UNITED STATES PATENT AND TRADEMARK OFFICE

10/624,038

Office Action Summary

DETAILED ACTION

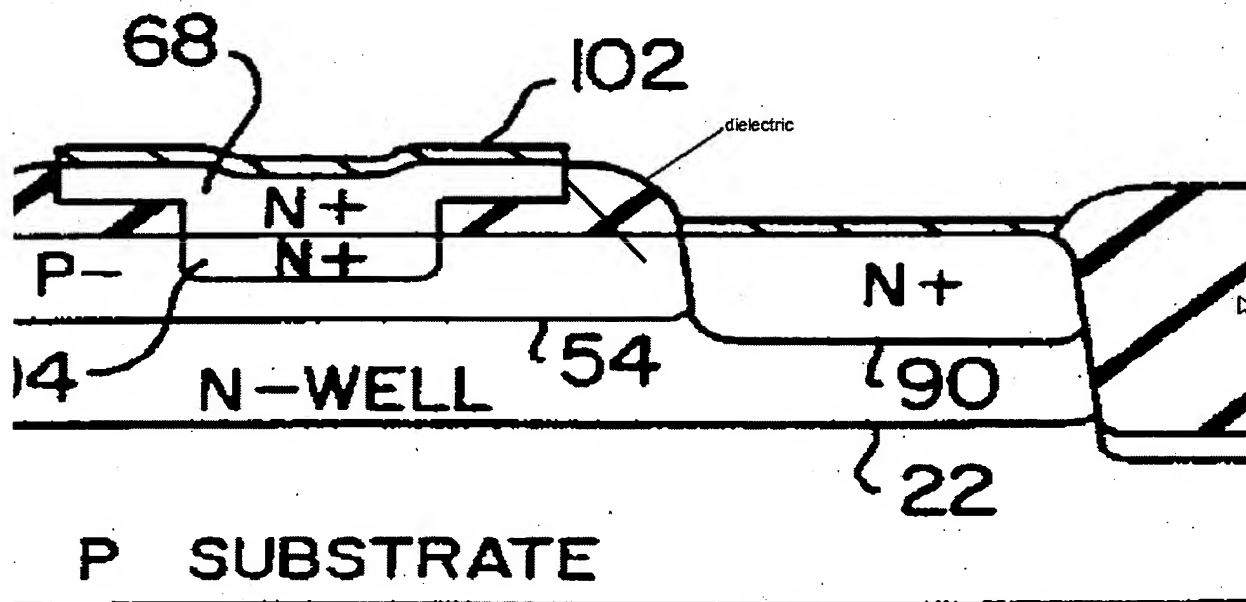
The argument that “Spratt's Figure 12 does not ... show dielectric layers 44, 84 as being interposed between an extrinsic portion of the base layer and a vertical portion of the top layer laterally that is encircled by said extrinsic portion of the base layer” is not persuasive. First the claim states:

a dielectric sidewall being interposed between the vertical portion of the top one of the layers and the extrinsic portion of the base layer; and

wherein part of the extrinsic portion of the base layer is located between the substrate and an extrinsic portion of the top one of the layers

Spratt in figures 9-12 clearly illustrates a dielectric sidewall 44, 84 being interposed between the vertical portion of the top one 68 of the layers and the extrinsic portion of the base layer 54: and wherein part of the extrinsic portion of the base layer 54 is located between the substrate 10 and an extrinsic portion of the top one 68/104 of the layers. There is dielectric between the vertical end of layer 68 and the extrinsic portion of the base layer 54.
